The action taken by this letter is considered to be within the scope of the current contract FIN B-0290. No change to cost or delivery of contract products is authorized. Please notify me immediately if you believe this letter would result in changes to costs or delivery of contract products.

John W. Bradbury  
Geochemistry Section  
Geotechnical Branch  
Division of Waste Management  
Office of Nuclear Material Safety  
and Safeguards

Figure B

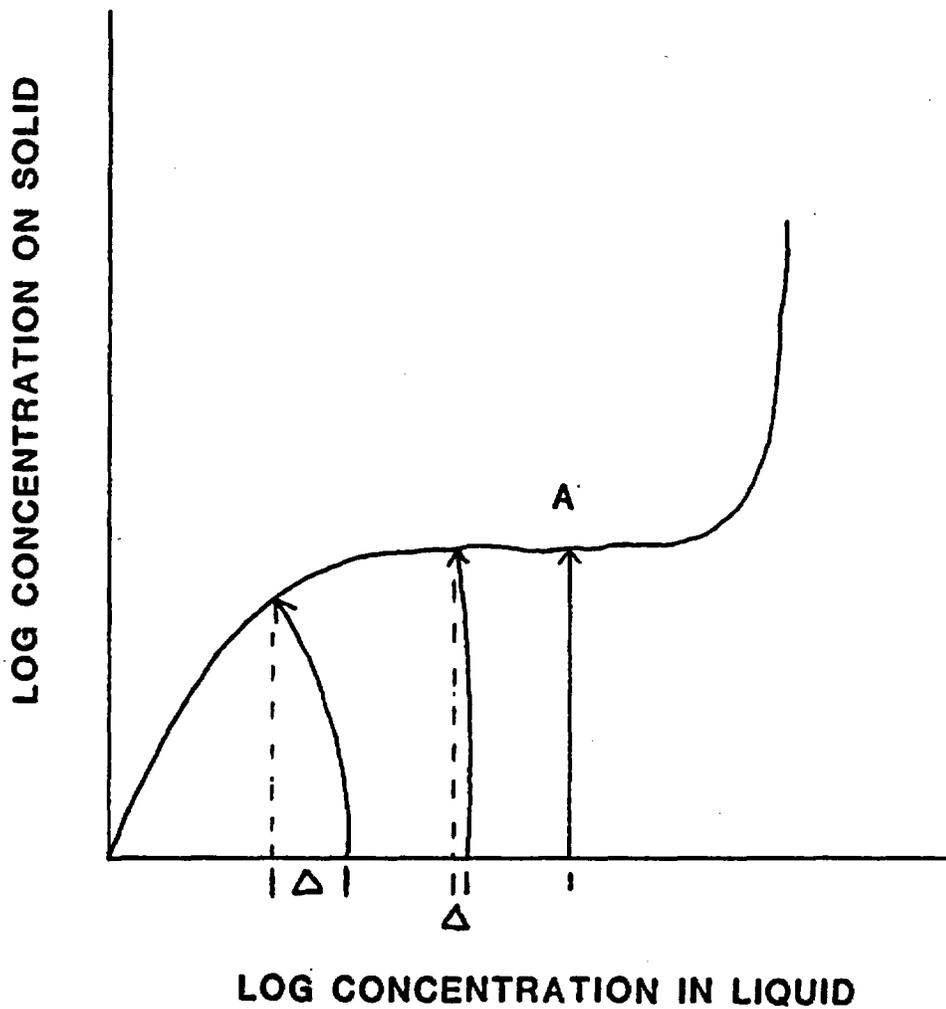
initial and final radionuclide concentrations in the liquid, an alternative explanation becomes apparent. Figure B illustrates that the change in concentrations in the liquid ( $\Delta$ ) approaches zero as the initial radionuclide concentration in the liquid becomes much greater than the final radionuclide concentration in the solid. Thus, at high radionuclide concentrations in the liquid, calculated  $R_s$  is zero even though the maximum amount of radionuclide is sorbed onto the solid. Disregarding radioactive decay, sorption on the vessel walls, etc., the sorption ratio,  $R_s$ , can be calculated from

where ml is the milliliters of liquid, g is the grams of solid, counts is the number of decays in the liquid per unit time, i is initial, and f is final. From this equation, it is apparent that at constant  $R_s$  the ratio of phases can be changed so that  $(counts_i - counts_f) \neq 0$ . Thus, by decreasing the water:rock ratio, the region in which sorption ratios can be measured (calculated) is increased.
